**CONWAY**  
HISTORIC DISTRICT COMMISSION  
**OCTOBER**

## **CONWAY HISTORIC DISTRICT COMMISSION MEETING**

**OLD CONWAY DESIGN OVERLAY DISTRICT  
CERTIFICATE OF APPROPRIATENESS REVIEW  
COVERED CARPORT ADDITION  
611 MITCHELL STREET**

**OLD CONWAY DESIGN OVERLAY DISTRICT  
DISCUSSION AND PRE-REVIEW  
OLD CONWAY VILLAGE, LP  
675, 725, & 819 SIEBENMORGEN ROAD;  
1317 & 1323 FACTORY STREET**

Staff provided sketch showing massing and scale

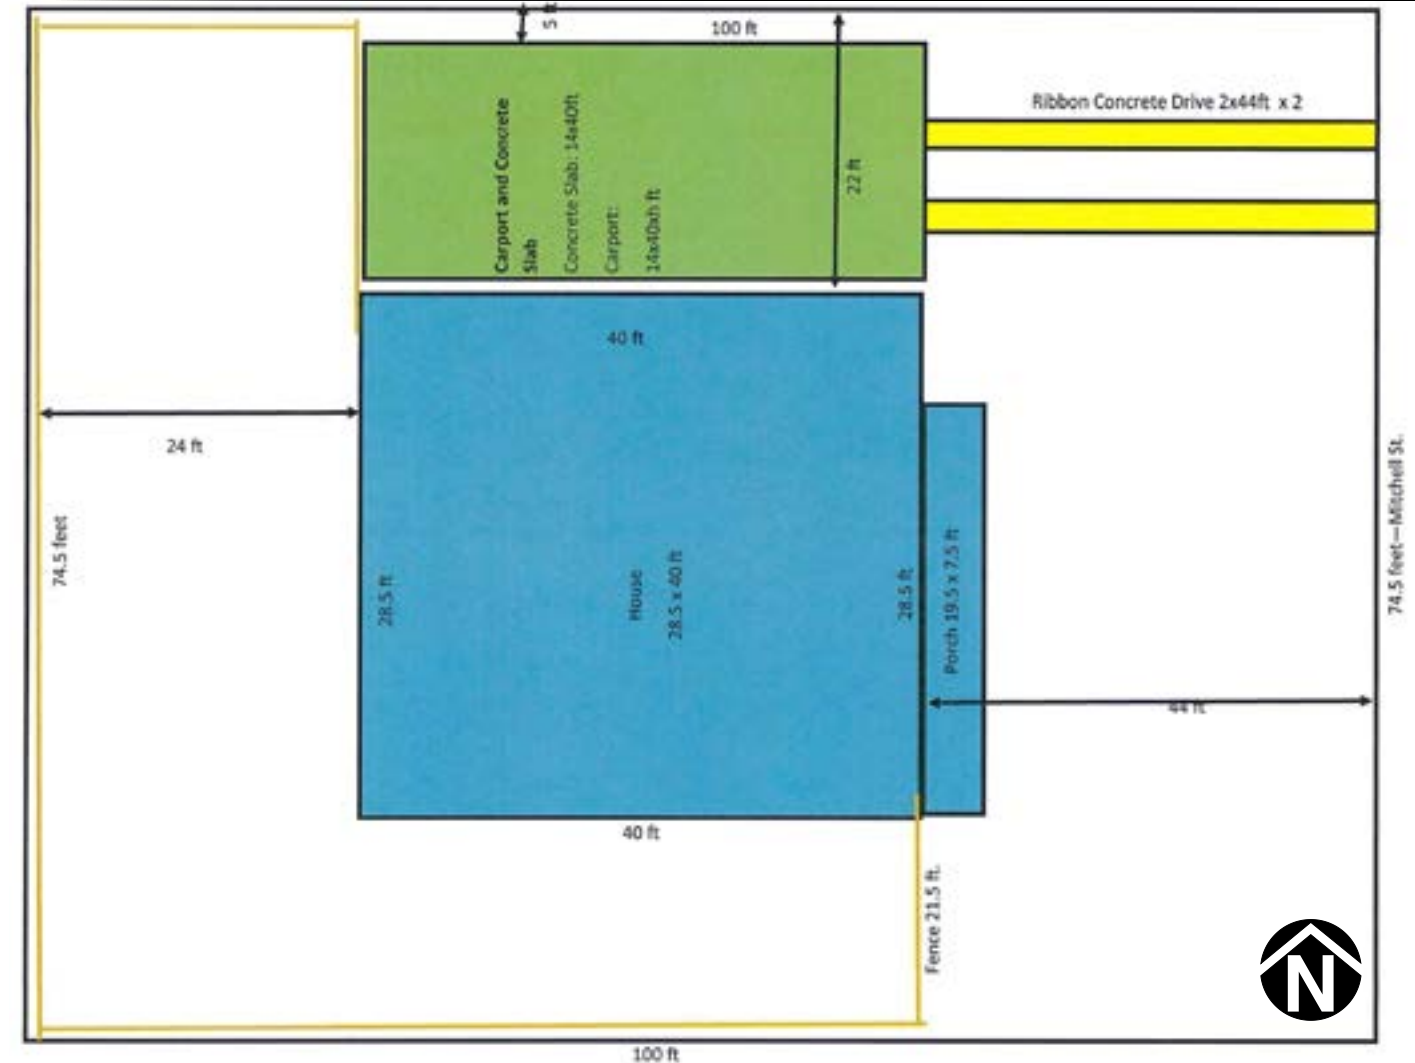
**Scale.** The size of new construction in relation to neighboring structures and the proportion of structures to the human scale. The carport is in scale with the residence or other area structures.

**Height.** The average height of area structure’s eaves and cornices. Also, the first floor elevation / height relationship. The 10 foot height is nicely proportioned with the existing residence. The carport has a slightly sloping shed roof.

**Width.** New construction proportions shall respect the average widths of the majority of neighboring buildings in the area. The carport’s width is around 14 feet. The overall width seems appropriate with the existing residence and other area structures.

**Directional expression.** Measurement of the height to width ratio of a structure’s elevation. The height/vertical expression of the carport is in proportion to the existing home’s eave line.

**Footprint.** The area of land covered by a structure should be in relation to the majority of neighboring structures. The residence’s habitable footprint area is unaffected. The footprint of the carport structure is long in nature at 40 feet, however, the deep length will largely not be visible from the street. It is assumed that the 40 foot depth is desired to allow two cars to be placed under the carport.

1. The 14’ wide x 40’ long x 10’ high carport, parking slab, and ribbon driveway shall be constructed as shown on the submitted plan.
2. The style of the carport shall be as shown in submitted photos with open rafter tails and substantially sized beams and joists.
3. Carport post shall be trimmed to be 8” x 8” minimum in size.
4. A corrugated metal roof shall be allowed.

Site Plan - Option #1

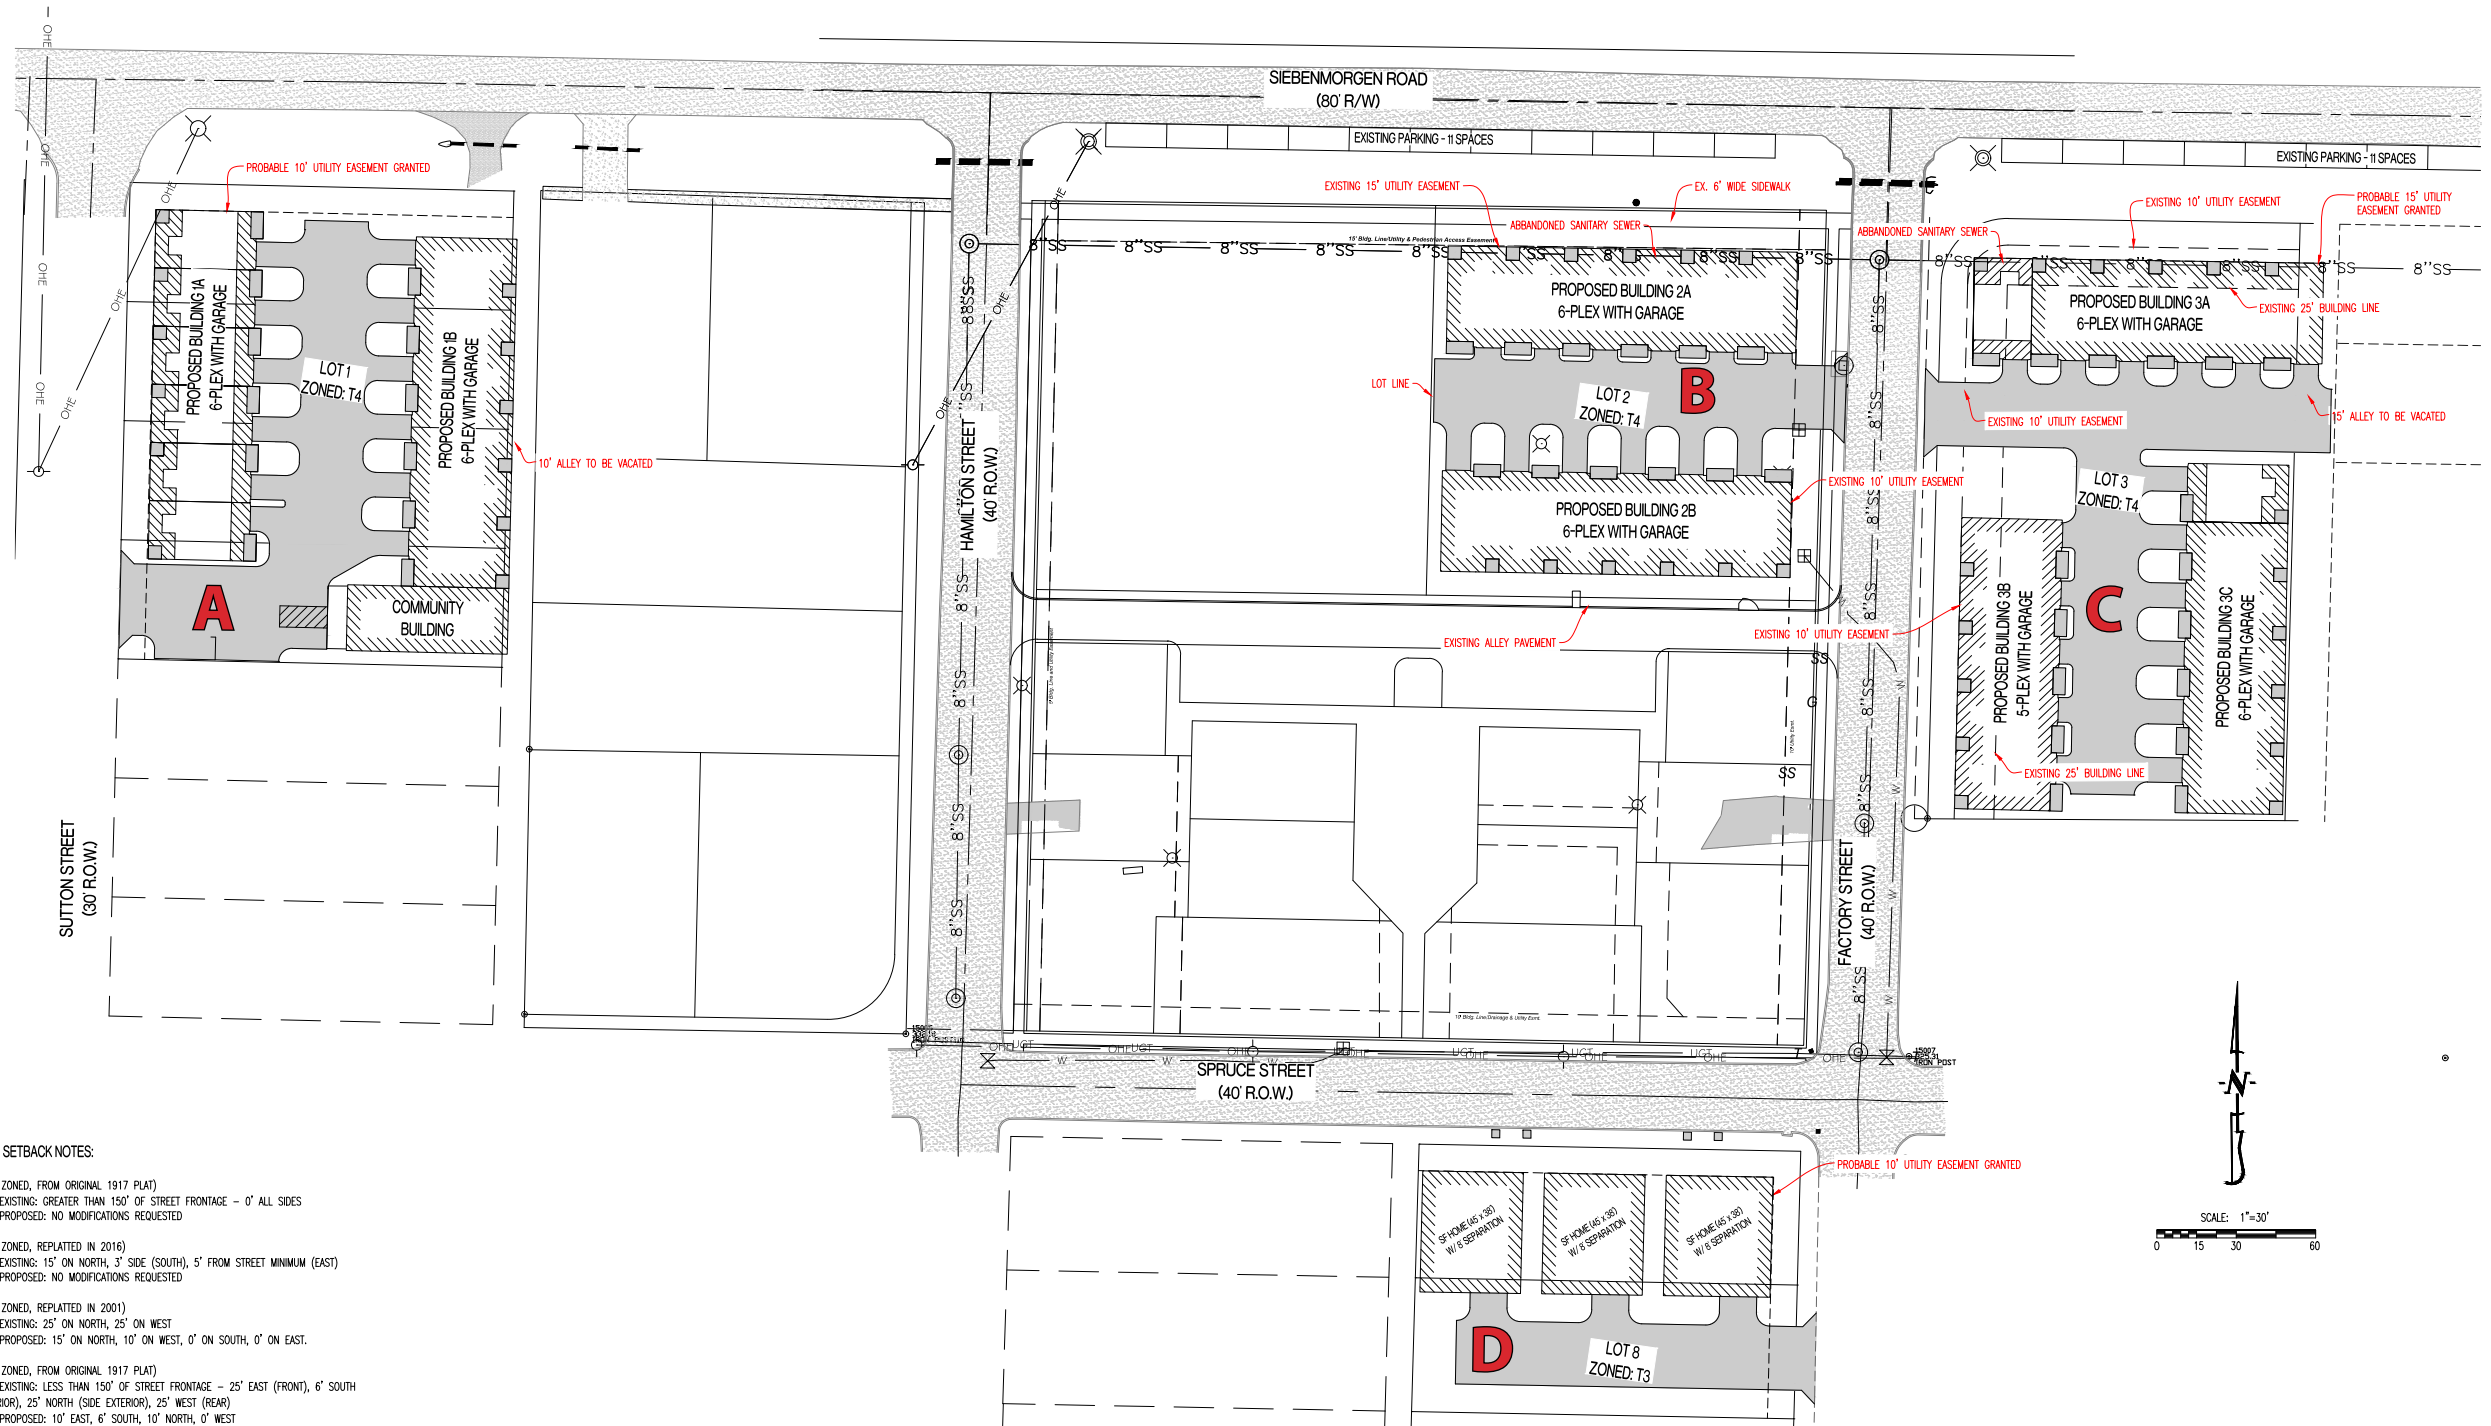
It is likely that some setback variances will be requested to construct as proposed. The NEOCA Plan area is a subset of the Old Conway Design Overlay District. As such, the HDC can grant variances to the above setbacks. The HDC should use the NEOCA setbacks as a guide to determine appropriate setbacks. The area is largely vacant making it difficult to use existing structures to determine an average area setback. The applicant will need to provide more detailed plans to establish suitable setbacks.

**Orientation.** The direction in which the front of a building faces. Most townhomes are oriented to face abutting streets. However, 3 units are facing internally with the "front" facade facing abutting property (Parcels A, B and C. The rear of the units on A and C will be facing the abutting property. The front facade of the internal unit on Parcel B will be facing a newly constructed alley.

**Alley.** There are 3 unbuilt alleys and one newly constructed alley in the project area. An alley in area A and part of an alley in area C will need to be closed in order to construct as proposed. Alley closing documents are being prepared for City Council approval. The newly constructed alley will be used as the "front" of townhome units in Parcel B.

**Driveway/Parking/Carport.** Driveways and parking areas are planned for each townhome unit. The parking areas will be internally located between townhome units and will serve as the garage entry points. The townhome buildings will screen the parking areas and present a more pedestrian friendly facade to the public streets and alley. Proposed single family structures will have driveways accessed from an alley with rear garage entry.

1. Setbacks and any possible variances will need to be determined.
2. Tree preservation, remediation, possibility of street trees.
3. Landscaping details.
4. First floor heights and front entry heights.
5. Methods to create a more "individual" look for townhome and single family units.
6. North facing facades in Area A.
7. Porch depths/design to "individualize".
8. Siding and fascia materials.
9. Shutters - if used.
